Response to Reviewer 1

This study conducts systematic post-event field surveys and hydrodynamic numerical simulations for the storm surge disaster induced by Typhoon Hato in Guangdong Province. This work produces valuable ground truth data and model validation references for estuarine storm surge research. However, several aspects of the article require improvement.

Figure 5. Comparison between the simulated and observed water levels during Typhoon Hato from 0:00 on August 20 to 0:00 on August 25.

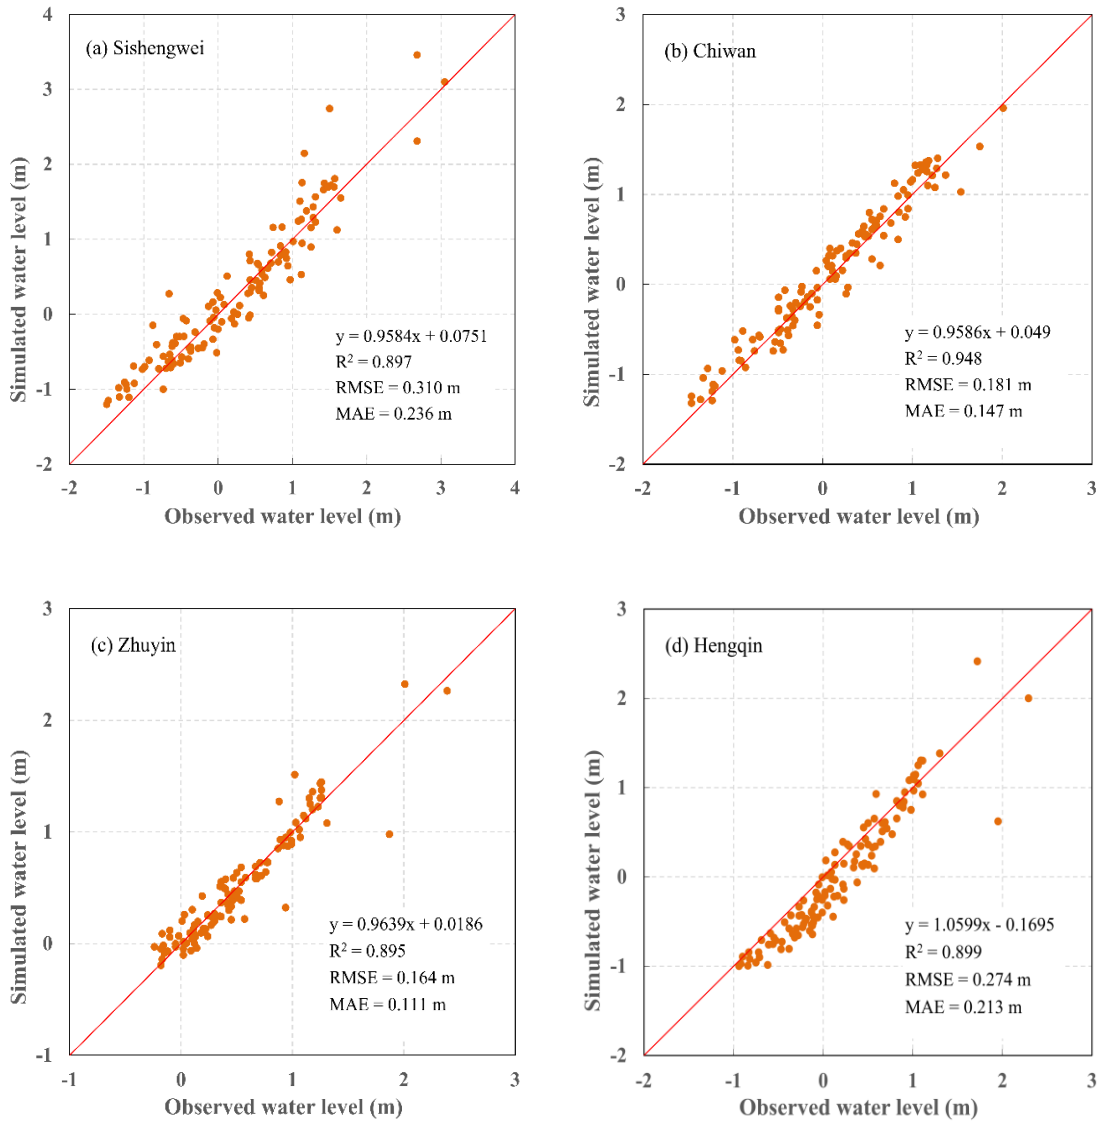
4. The manuscript includes comparisons between simulated water levels and observed data, yet it lacks sufficient quantitative evidence for model validation. Statistical error indices need to be supplied to quantitatively demonstrate model performance.

Thank you for your valuable comment. To provide quantitative evidence for model validation, we have added a systematic comparison between the simulated and observed hourly water levels at four tidal stations. The model performance was quantitatively evaluated using the coefficient of determination (R^2), root mean square error (RMSE), and mean absolute error (MAE). The results show strong agreement between the simulated and observed water levels, with R^2 values ranging from 0.895 to 0.948, RMSE values from 0.164 to 0.310 m, and MAE values from 0.111 to 0.236 m. In addition, we have revised the structure and corresponding subsection titles of the Results section. A new subsection "3.4 Model Validation" has been introduced to integrate the water-level validation with the subsequent comparisons of inundation extent and inundation depth. Details of water-level validation are as follows:

To quantitatively evaluate the performance of the hydrodynamic model in reproducing the temporal evolution of water levels during Typhoon Hato, simulated water levels were compared with hourly observations at four tidal stations (Figure 5). Overall, the simulated and observed water levels showed a strong linear correspondence

across all stations, with coefficients of determination (R^2) ranging from 0.895 to 0.948. The relatively high R^2 values indicate that the model successfully captured the temporal variability of water levels during the event, including the overall rising and falling patterns associated with tidal fluctuations and storm induced water level changes. The magnitude of the errors was generally moderate, with RMSE values ranging from 0.164 to 0.310 m and MAE values ranging from 0.111 to 0.236 m. The best agreement was obtained at Zhuyin, where the model achieved an R^2 of 0.895, an RMSE of 0.164 m, and an MAE of 0.111 m, while Chiwan showed the highest R^2 (0.948) and relatively low errors (RMSE = 0.181 m; MAE = 0.147 m). Sishengwei exhibited the largest deviations, with an RMSE of 0.310 m and an MAE of 0.236 m, suggesting greater uncertainty in reproducing the local water-level response. At Hengqin, the regression slope was slightly greater than unity (1.060), indicating a modest amplification of the simulated water-level variability relative to the observations, whereas the slopes at the other three stations were slightly below unity (0.958–0.964), suggesting a generally consistent but slightly compressed response amplitude. The close correspondence between simulated and observed water levels across the four stations demonstrates that the model reasonably reproduces the hydrodynamic response to Typhoon Hato and provides a reliable basis for subsequent assessment of inundation extent and depth. The model performance was therefore further evaluated by comparing the simulated inundation extent and depth with field observations. (Line 251-267 in the revised manuscript)

Figure 1. (a)Track and intensity variation of Typhoon Hato. (b) The spatial distribution of tidal stations (purple circles) and main field survey sites (red circles).

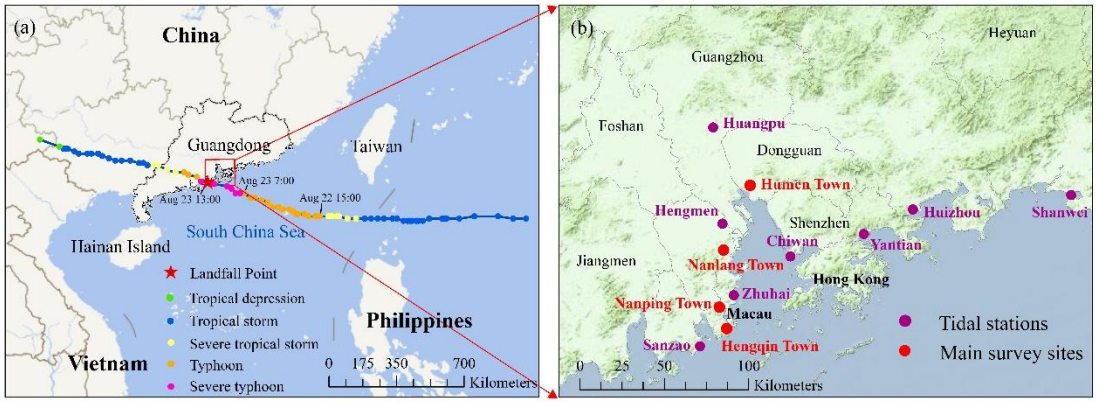
1. I suggest the authors add the geographic locations of observation sites mentioned in Table 3 onto spatial maps. This improvement can enhance visual readability for readers.

Thank you for your valuable comment. We have added the geographic locations of observation sites mentioned in Table 3 onto the study area map (Figure 1). The revised figure is as follows:
